Response to Submissions

For Development at Pollnagroagh and Rathmorrissy
on behalf of Bord Gáis Energy Limited

Client	Bord Gáis Energy Limited	
Project Title	Cashla Peaker Plant	
Document Title	Response to Submissions	
Document Comprises	Volumes	1
	Pages (Including Cover)	139
	Appendices	2
Prepared by	Muireann Carroll	
Checked by	Paula Galvin	
Office of Issue	Dublin	
Document Information	Revision	C
	Status	Submitted
	Issue Date	July 2026

Figure 1 - View looking east

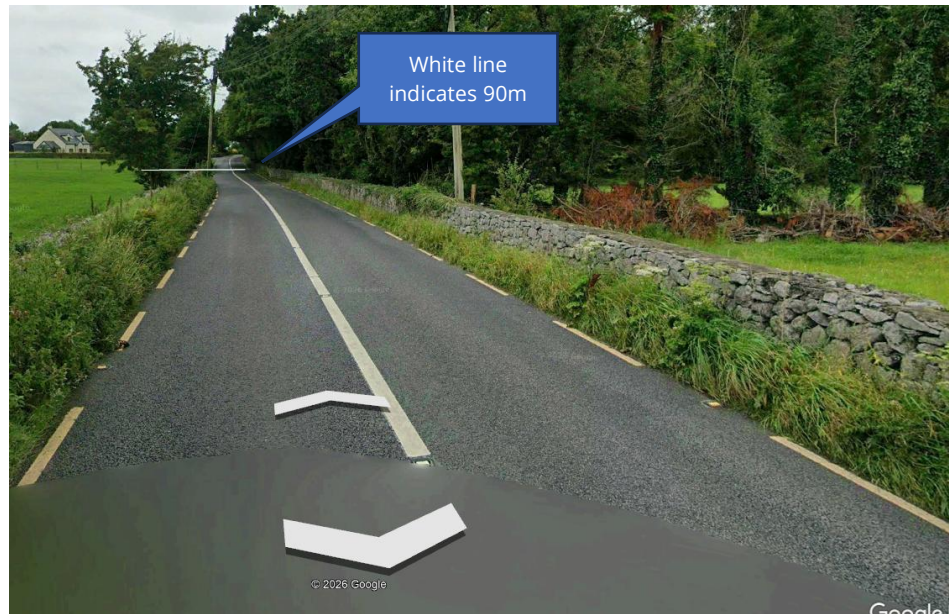
The Roads Department stated that sightlines and stopping sight distances for the proposed permanent substation entrance had not been adequately demonstrated. It requested revised site layout and longitudinal information, based on detailed topographical survey data, to show that 90m visibility can be achieved from a setback distance of 2.4m from the road edge. Supporting photographs were requested, together with details of any required boundary setbacks, including roadside walls, vegetation and stationary roadside objects such as overhead service poles. It also requested that the vertical envelope of visibility be demonstrated in accordance with the relevant TII standards. In addition, Galway County Council requested that any third-party boundaries affected by required sightline splays be clearly identified on revised drawings, and that written consent and supporting ownership details be provided where lands outside the applicant's control are needed to achieve visibility standards. The Roads Department also noted the absence of a Stage 1 / Stage 2 Road Safety Audit and required that such an audit be undertaken for the entire scheme, with all issues raised to be addressed in revised layouts. It further stated that a detailed Traffic and Transport Assessment should be prepared in accordance with TII guidance, and that this assessment should also consider indirect road safety impacts, including the effect of the proposed 20m public lighting mast and the absence of lux contouring and glare assessment.

The visibility assessment is demonstrated on Drawing PEK3-ATK-ZZ-01-DR-CE-901200. Additional photographs and illustrative profiles are provided below to assist in explaining the available horizontal and vertical visibility.

Figure 1 and Figure 2 illustrate views from the road looking east and west respectively. Figure 3 and Figure 4 illustrating the available vertical visibility in both directions. Figure 5 confirms that the existing wall to the east lies outside the visibility envelope, while vegetation and roadside obstructions to the west are identified for removal or relocation in drawing PEK3-ATK-ZZ-01-DR-CE-901200 – Site Access Sightlines.

It is proposed to remove all vegetation within the western sightline triangle and relocate overhead utility poles as required, such that no obstructions remain within the 90 m visibility splays. All identified obstructions will either be removed or relocated outside the sightline envelope, ensuring full compliance with the required visibility standards. The lands affected by these works are within the ownership of Paddy and Caroline Forde. Written consent from the landowners was submitted as part of the planning application documentation. Drawing PEK3-ATK-ZZ-01-DR-CE-901200 – Site Access Sightlines clearly identifies the extent of the sightline triangles and the associated works within these lands, including the removal and relocation of obstructions

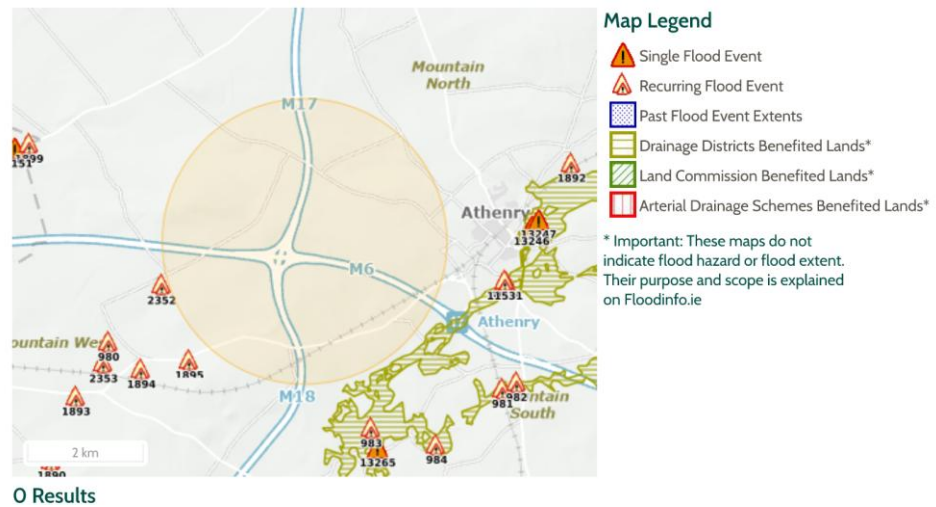
With respect to the OPW comment regarding the statement that “no flood maps were available”, the Applicant acknowledges that OPW Floodinfo mapping is subject to ongoing updates and inherent limitations. The FRA has therefore not relied solely on Floodinfo outputs but instead incorporates a multi-source, evidence-based assessment, including historical mapping, hydrological review, GSI datasets and site-specific topographical considerations. This aligns with the intent of the Guidelines to consider all sources, pathways and receptors of flood risk.

The findings of the Stage 1 FRA demonstrate that there are no credible flood sources or pathways that could give rise to flood risk at the site, and that the development will not increase flood risk elsewhere. In accordance with the staged approach set out in the Guidelines, and given the absence of identified flood risk, progression to Stage 2 or Stage 3 assessment is not required. The reader is referred to Figure 6, Figure 7, Figure 8 & Figure 9 for reference.
